PETITION FOR APPROVAL OF  
PROJECT DESIGN REFINEMENTS  
MARSH LANDING GENERATING  
STATION  
(08-AFC-3C)

**GenOn Marsh Landing, LLC**

**URS Corporation**

January 2012

**FIGURE 2.0-1**

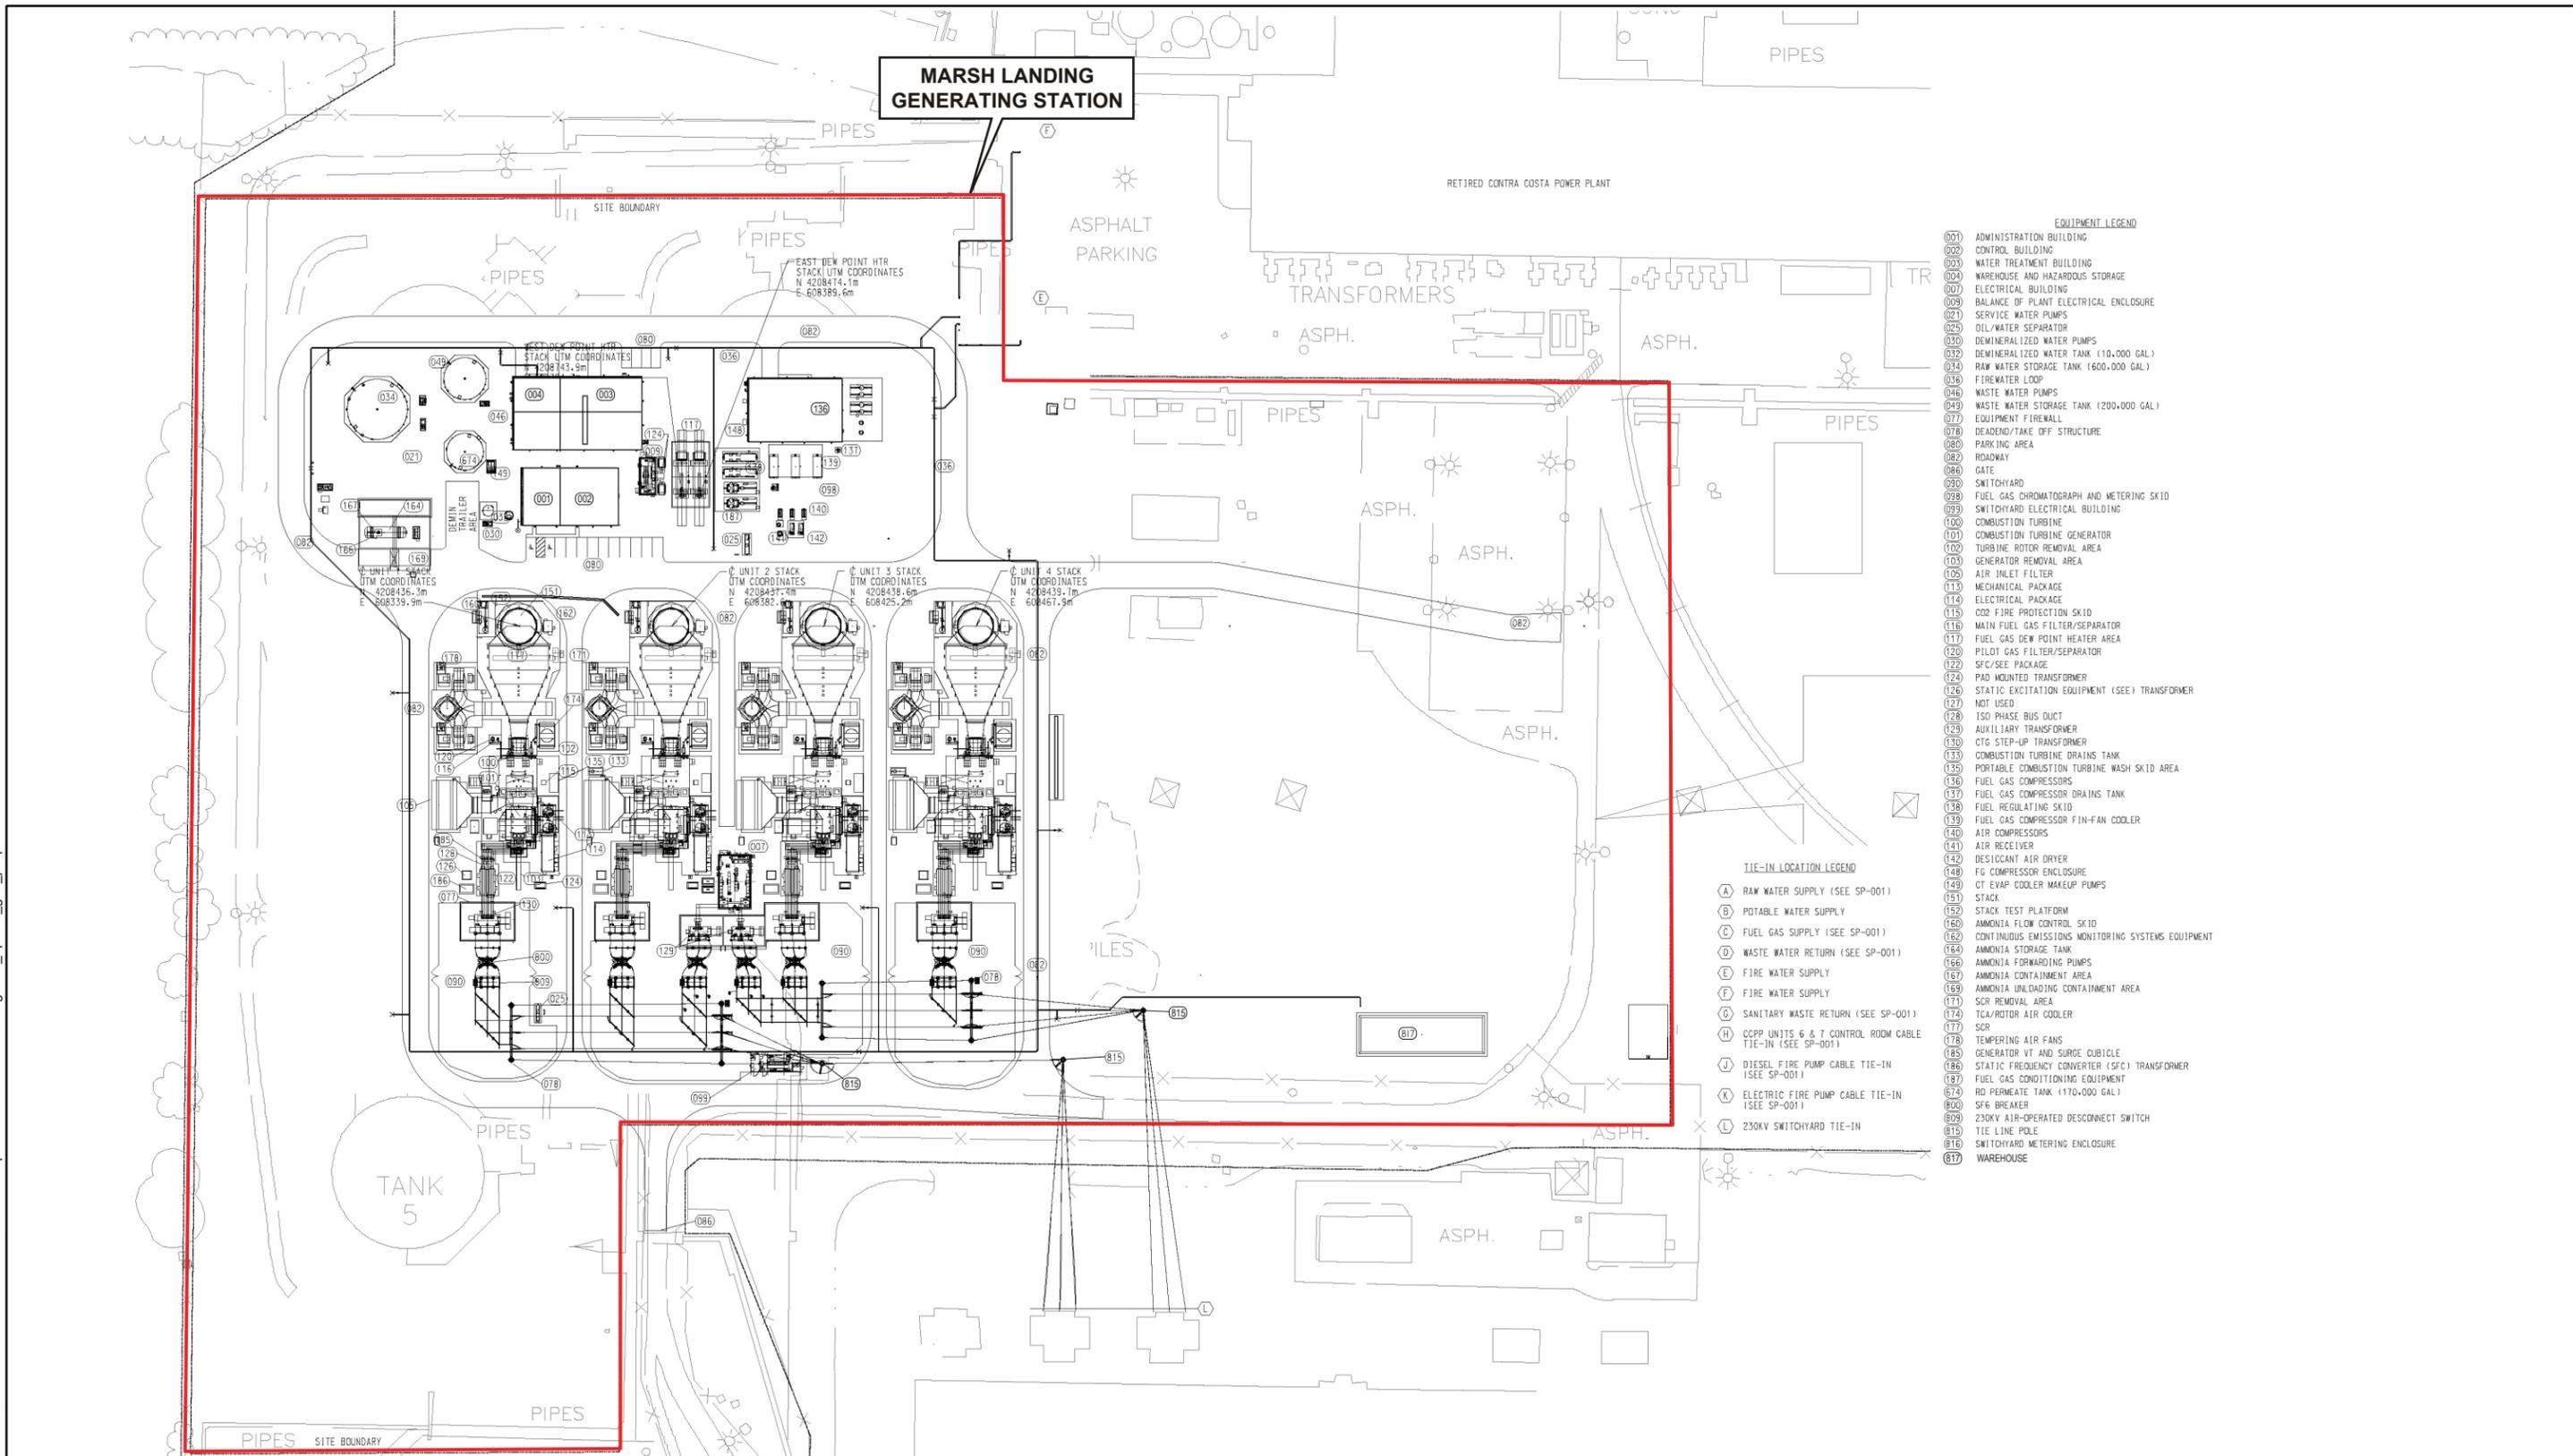
Refinements to the project are listed below. Figure 2.0-1 shows the current plot plan for the project.

- The construction warehouse, which originally was going to be removed by the contractor after the MLGS commercial operation date (COD), will be purchased by GenOn Marsh Landing and used as a machine shop. As shown on Figure 2.0-1 it is located in the

southeastern portion of the MLGS site. The footprint of the warehouse building will be 4,800 square feet (40 feet by 120 feet). The height of the building will be 17.5 feet. It will be hidden from view at Wilbur Avenue by the switchyard equipment and the 'green belt' south of the switchyard. It will be hidden from view at the river by the Contra Costa Generating Station (CCGS) power building.

- The MLGS interconnection to the PG&E switchyard has been modified to integrate with changes PG&E is making in the switchyard. PG&E is replacing the breakers in their switchyard and rebuilding their dead-end structure where the MLGS generators connect within their switchyard. As a result, the arrangement and locations of the transmission tie line poles have been adjusted as shown on Figure 2.0-1, Updated General Plot Plan. The tie line poles will still be 100 feet tall. A switchyard building (099 on the Updated General Plot Plan) is now included and will also house the switchyard metering equipment.

- The tempering air fans will no longer be inside a building (i.e., replaces the air blowers shown on Revised Figure 2.5-1 in the 2009 AFC Amendment) and will have silencer housing on the inlet ducts. Each unit will have two 2,000-horsepower (HP) single speed fans. Both fans will be on the west side of each unit, as shown on the updated plot plan.

The project design refinements include relocation, addition and elimination of some structures as shown on Figure 2.0-1. However, these changes will be visually imperceptible when the project is viewed as a whole. This is because the largest features associated with the project (e.g., exhaust stacks and combustion turbine generators) will not be relocated as a result of these refinements. While the project design refinements would relocate the control/administration building, replace the water treatment trailers with a new water treatment building, relocate one of the water storage tanks and add a new warehouse, these changes would not add any visual point of interest to MLGS. Furthermore, none of these structures would visually dominate the site, nor would they create a visual point of interest due to their size and color in relation to the other plant facilities. Therefore, while the expansion, addition, and relocation of these structures will slightly alter the layout of the project as a whole, these changes will not modify the existing analysis or conclusions presented in Section 7.11 of the AFC or the AFC Amendment. Therefore, potential visual impacts at all seven key observation points are expected to remain less than significant with implementation of the Conditions of Certification adopted in the Commission Decision.
